# Royal Far West Concept Plan - Modification 1

Section 75W Modification Assessment  
MP 10\_0159 MOD 1

April 2022

**Figure 26** Plan showing proposed changes to Drummond House, compared to the approved layout (Source: Proponent’s Response to Submissions)

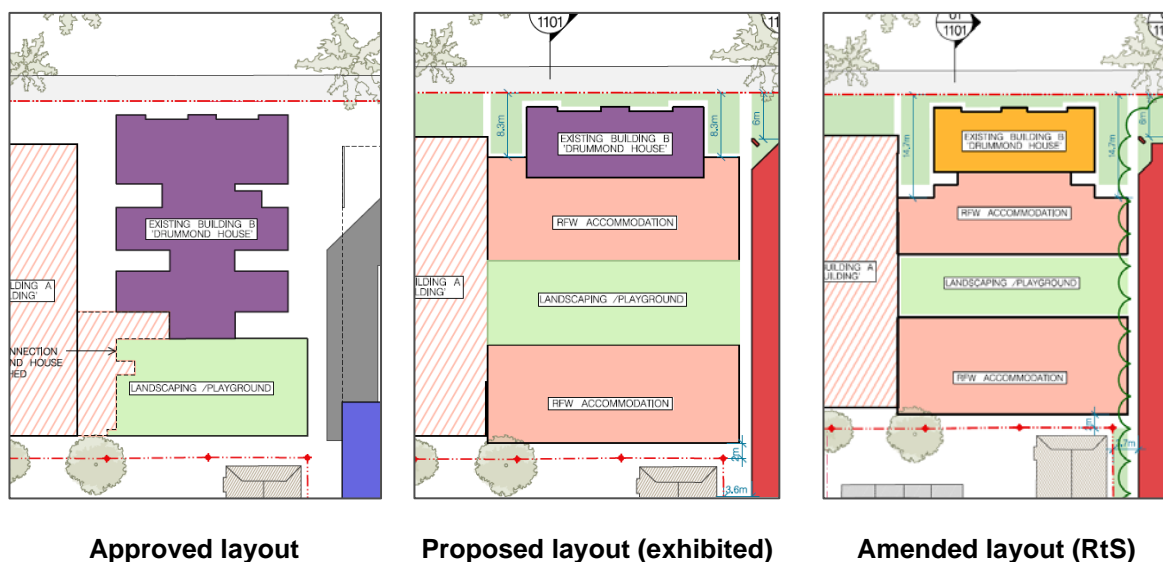
During the exhibition, Council advised that it did not support the proposal due to heritage impacts, as it does not retain significant built fabric of Drummond House. Heritage NSW advised that, as the site is not listed on the State Heritage Register, it had no comments on the proposal. While not a major issue, 2% of public submissions raised concerns about potential heritage impacts of the proposal.

In response, the Proponent amended the proposal to reduce heritage impacts on Drummond House (**Figure 26**). This included increasing the setback of the new RFW accommodation building envelope to Wentworth Street (from 8.3m to 14.7m) so that more of the façade and front bay of Drummond House is visible from the street.
